#### **5. Rezoning Application No. 00468 for 1070 Joan Crescent**

**Subject:** Rezoning Application No. 00468 for 1070 Joan Crescent

**RE: 1070 Joan Crescent revised proposal for Rezoning and Heritage Alteration Application.**

A3.10

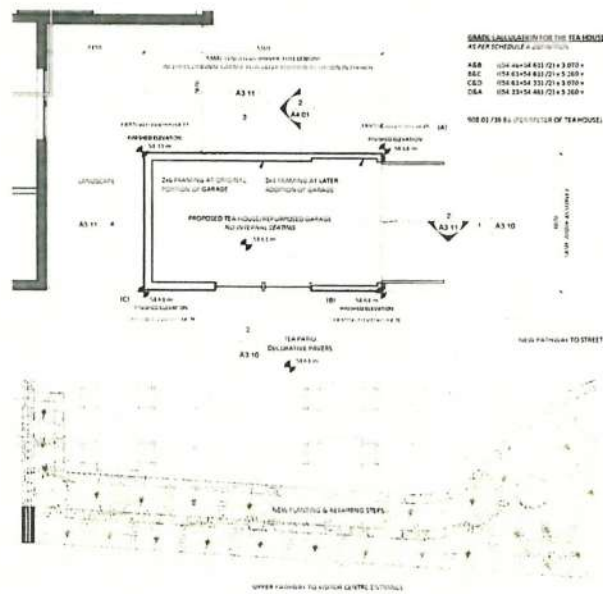
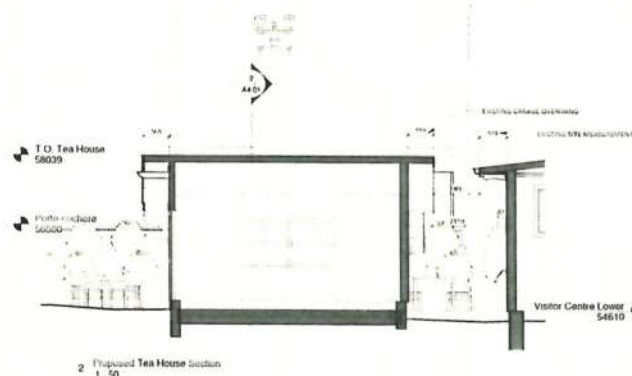
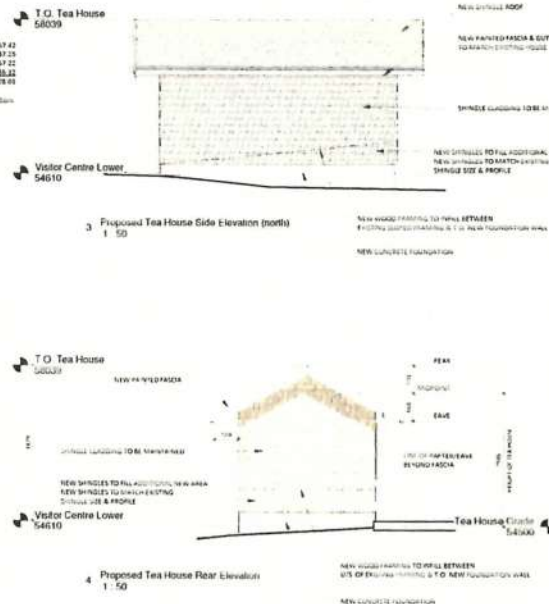
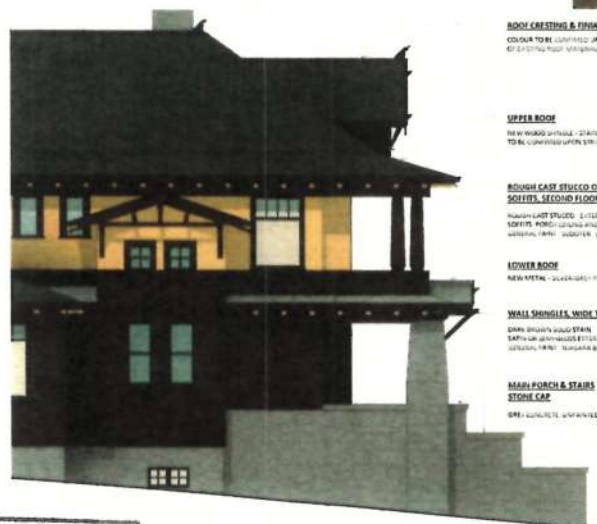
**4. *Please provide a detailed relocation plan for the existing garage/proposed Tea House.***

The intent is to relocate the superstructure of the existing garage in its entirety. The existing foundation is not reusable and the garage will be placed on a new concrete foundation. The slope of the wood framing is to be retained and new framing will be filled in for connection to the new foundation. Special consideration will be taken to ensure the slope is represented for interpretive purposes. Additional detail of the garage is provided on sheets A3.10 & A3.11.
